## Product Change Notice (PCN)

**PCN Number:** PCN-0450735R-01

Product(s) Affected: *PJ-014DH-SMT-TR*

Recommended PCB Layout Top View

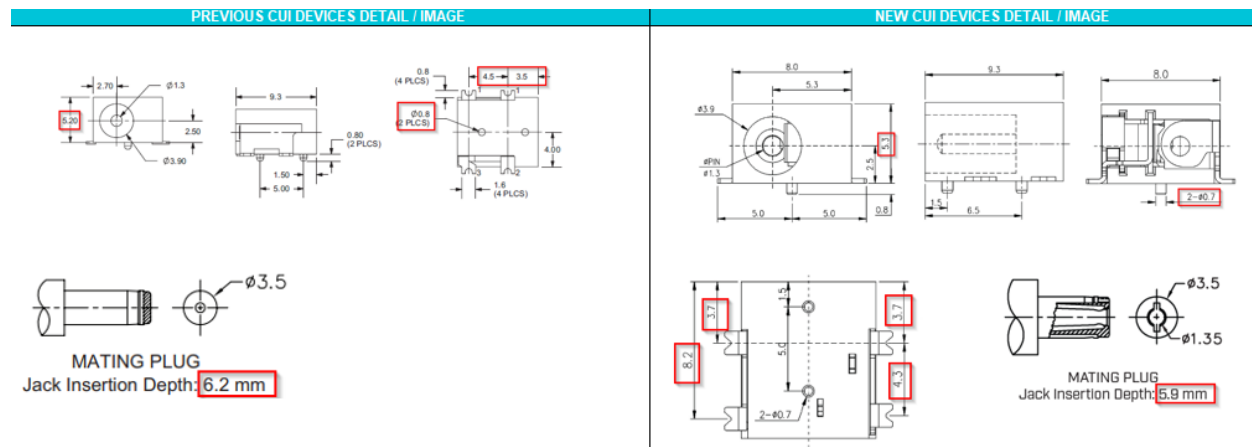
Description of Change: *Mechanical, electrical, and material changes as shown below:*

MATERIAL	PLATING
center pin	copper	nickel
terminal 1	brass	silver
terminal 2	copper alloy	silver
terminal 3	brass	silver
plastic	PA6T or equivalent

DESCRIPTION	MATERIAL	PLATING/COLOR
center pin	brass	silver
terminal 1	brass t=0.50	silver
terminal 2	bronze t=0.25	silver
terminal 3	brass t=0.50	silver
housing	PA10T (UL94V-0)	black
